APPENDIX C.2
Geotechnical Inspection Report

Submission of Annual Geotechnical Inspection – 2024, Mary River Project – Nunavut, Project # CA0039374.4332

2024 Geotechnical Inspection Recommendations and Implementation Plan

Figure 32: Section at the upstream side of the main dam (note the detail within the red rectangle at the left, showing an anchor trench into the permafrost). – Source: KM105 Sedimentation Pond Design Brief and Issued for Construction Drawings – Knight Piésold Ltd. 2021

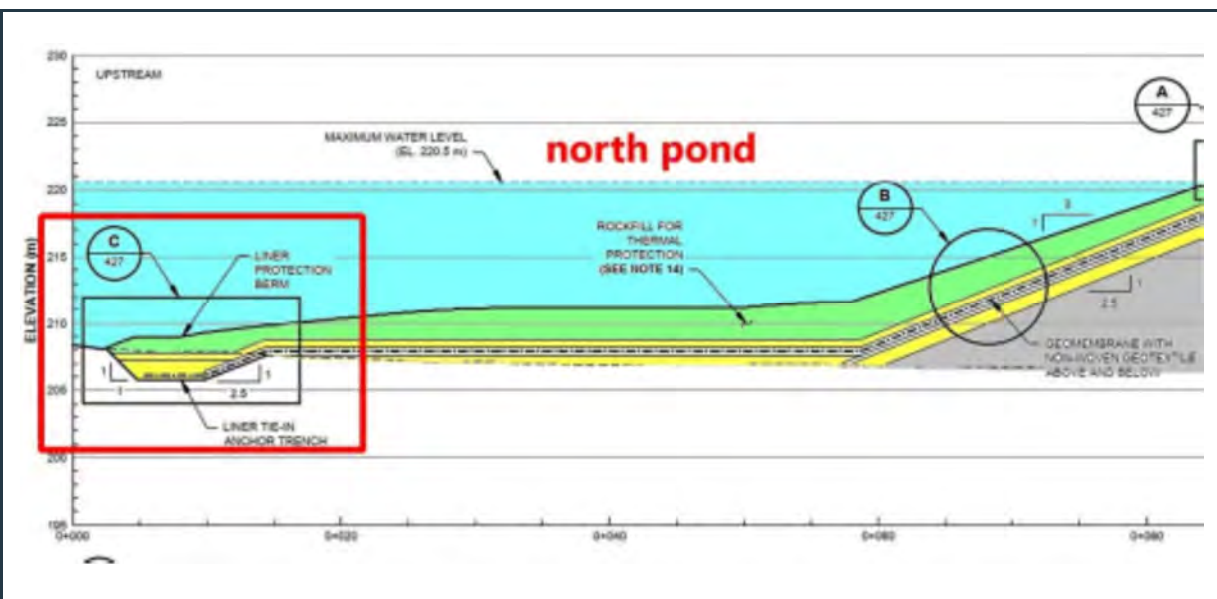
The design of the pond's main dam included an emergency spillway with an invert elevation of 220.5 m, which is the design maximum water level in the MS-11 pond. At normal water level the pond has two separate (but connected) areas: the "north and south ponds", as shown in Figure 4. As specified in the 2021 design, the upstream slopes of the main dam and sections of the side slopes within the north and south ponds (yellow areas in Figure 4) are lined with HDPE geomembrane, placed between two layers of non-woven geotextile, and gravelly sand base and cover layers, and topped with a layer of crushed rock riprap for erosion protection (see Figures 32 and 33).

Figure 34: Section of the side slope in the south pond. – Source: KM105 Sedimentation Pond Design Brief and Issued for Construction Drawings – Knight Piésold Ltd. 2021

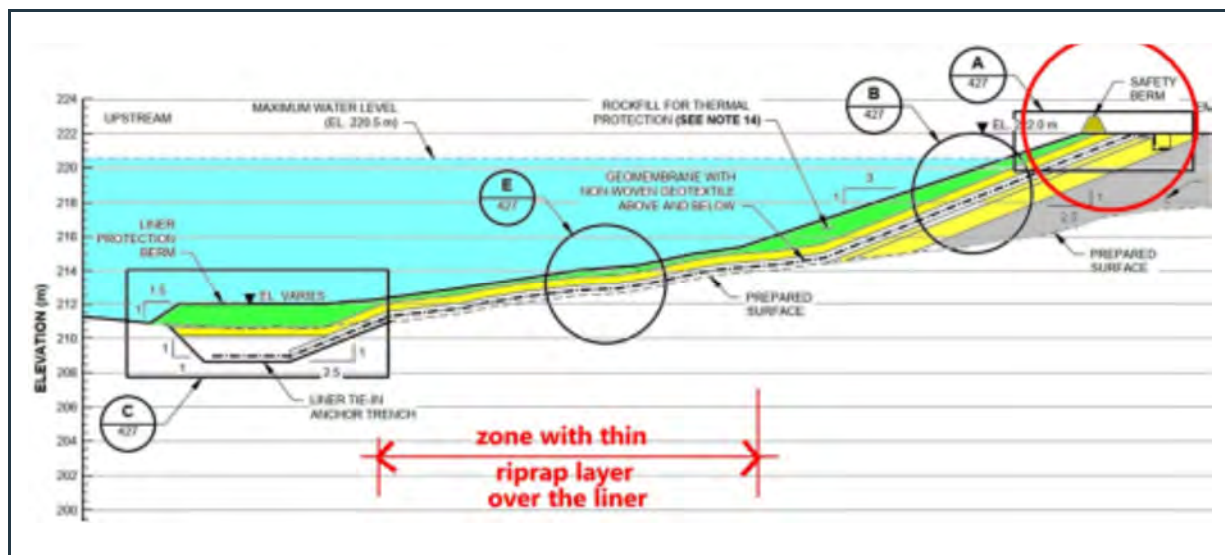
On the side slope of the south pond, the geomembrane liner and non-woven geotextiles extended up to the top of the slope of the embankment and were anchored into an anchor trench at the crest, as shown in Figure 34.

- The other is that one of the safety berms, constructed on the top of the riprap layer, immediately adjacent to the anchor trench at the crest of the embankment (see the red circle in the image). Based on information recently obtained at the mine it appears that during the filling of the ponds with runoff water, around June 11 and 12, 2022, sliding/sloughing of the cover layers and the displacement of the safety berm was noted along the crest of the embankment at the south pond. Figure 35, which was taken on June 22, 2022, shows the slipping (and cracking) of the cover layers (sand and riprap) and the downslope displacement (sliding) of the safety berm just a few weeks after the completion of the construction and during the early stage of filling the pond with water.

Figure 36 was taken during the recent site visit on August 26, 2024, which shows that the liner beneath the cover layers is still intact and anchored into the anchor trench at the top of the embankment's slope. This indicates that only the cover layers and the safety berm have moved (slipped) in June 2022, and that there was no "classical" slope failure within the embankment at the south pond. It appears that the embankment beneath the liner is stable, and the anchor trench is still at its original position along the edge of the crest (at road level), still supporting the liner as per the original design.

Figure 41: Satellite view of the solid waste landfill facility and the adjacent two, recently constructed landfarm cells (1 and 2). Cell 3 is proposed for construction in the future.

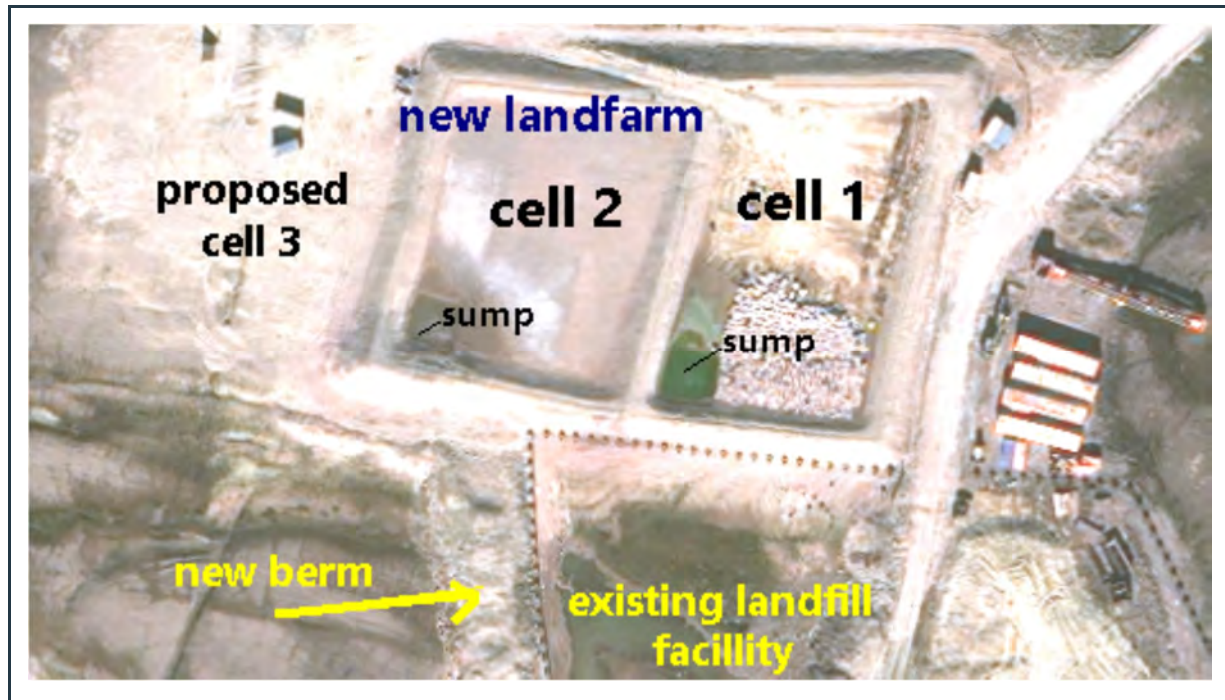
The non-hazardous solid waste disposal area is in the southern zone of the Mary River Mine site, as shown in Figure 6. Two (2) new landfarm cells were constructed near the gate of the main landfill facility, as shown in Figure 41. It is understood that the number of new landfarm cells may be increased to three (3) as shown in the image.

Figure 44: View of the stable berm around the currently empty cell-2 of the new landfarm. The ponding water indicates good liner performance. Note that the water should be removed prior to storing any material in this cell.

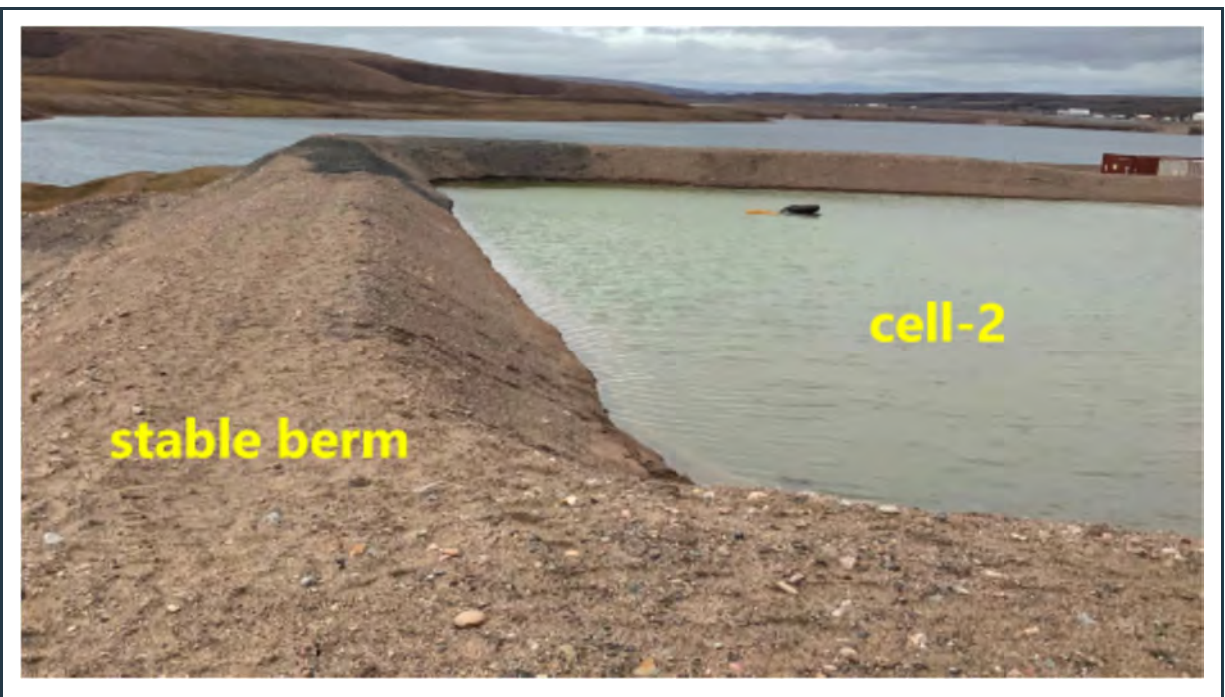
Figures 43 and 44 show the robust stable berms around the cells. During the August 2024 inspection it was noted that the currently empty cell #2 had lots of ponding water within the cell. This indicates good liner performance; however, the water should be removed and properly disposed, prior to storing any material within the cell.

Figure 87: View of the Western Globe Fuel Module (WGFM) north of the 380 Camp. No humps are visible at the entrance and exit points of the refueling station.

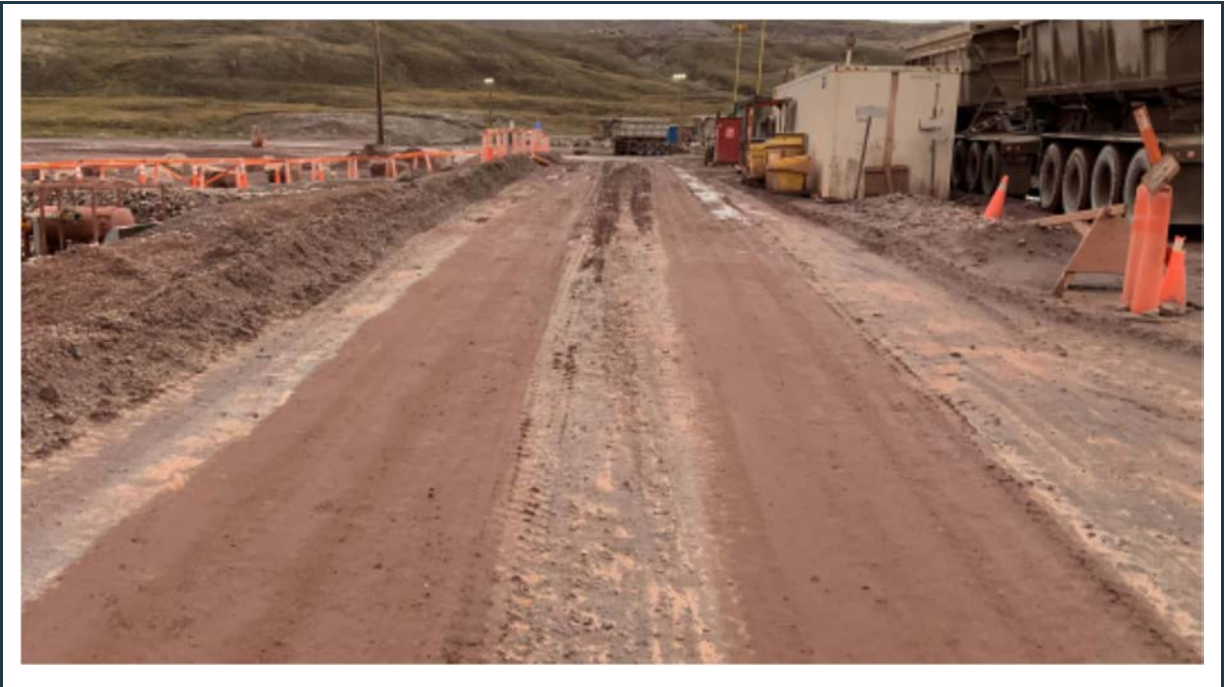
The Western Globe Fuel Module (WGFM), shown in Figure 87, is located north of the 380 Camp. As opposed to design specifications, no humps are visible at the entry and exit points of the refueling station. The top image of Figure 88 presents part of a historic design drawing (drawing number C01), showing a section of a 900 mm wide (at its crest) and 450 mm high drainage control hump with 10H:1V slopes, specified by B.H. Martin Consulting Engineer and Architect in June 2016. The purpose of the humps at the entry and exit points of the refueling station was to prevent oily surface water escaping the refueling area. As shown in the top image of Figure 88 the entire area of the refueling station has a liner beneath the road fill, which liner should also have a 10H:1V slope up to the internal edge of the 900 mm wide humps. Under the heavy truck traffic at the station; however, those humps were flattened/spread in the past but shall be reinstated. It is suggested that the edges of the liner beneath the road fill be exposed using hydrovac, and the humps reconstructed as designed. In addition, installation of timber beams is suggested within the humps, to prevent the flattening of the granular fill by the heavy trucks in the future, as shown in the lower image of Figure 88.

Figure 112: View of the inlet of three culverts at KM 90+100. Only one (green arrow) is operational.

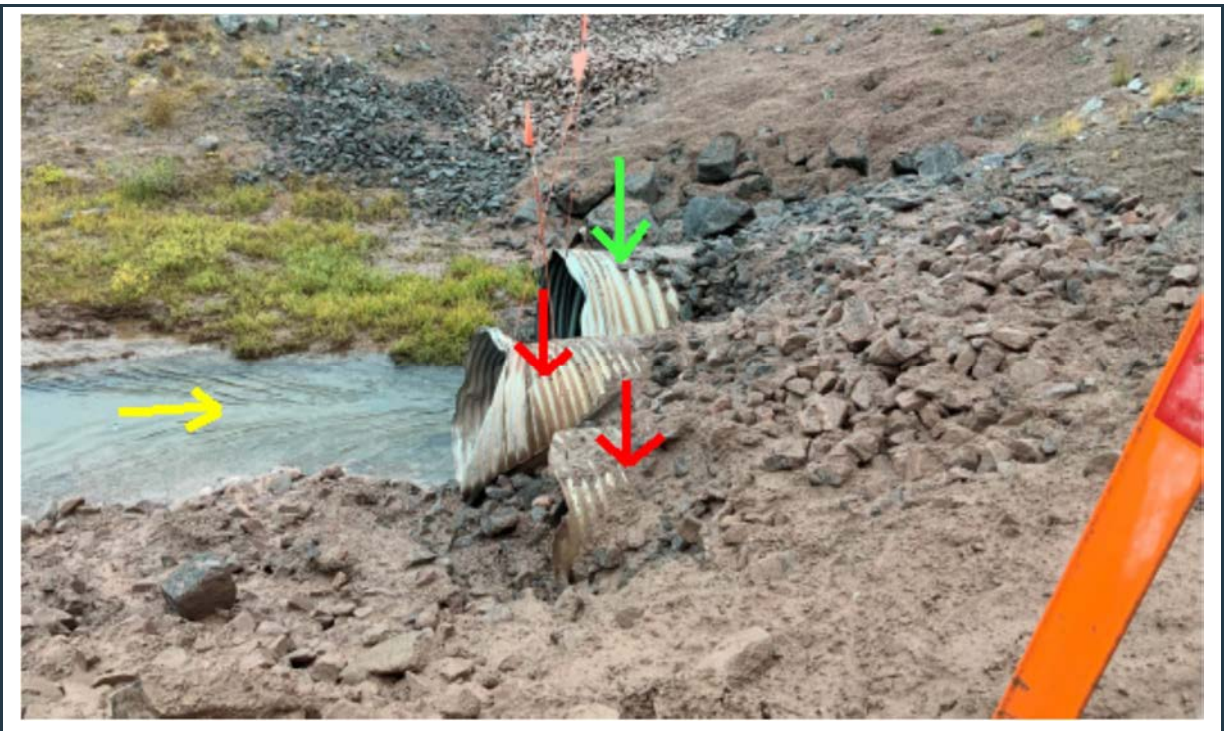
Figures 112 and 113 show the inlet and outlet of three corrugated pipe culverts, one relatively new (green arrow) and two old (red arrows) pipes. As shown in the images, only one of the three pipes is operational. Figure 113 also shows that the operational (green arrow) pipe is not perpendicular to the road, but follows the alignment of the stream, crossing the road at an angle (skewed barrel). Such culvert alignment may often result in increased erosion of the road embankment at the inlet and outlet ends of the culverts (note the yellow circle in Figure 113). It is suggested to closely monitor the embankment at both ends of this culvert and make appropriate steps (if needed) to prevent sloughing of the material at the toe of the road embankment, by lengthening the culvert at both ends, and by placement of additional riprap on the adjacent embankment slopes, particularly at the toe.
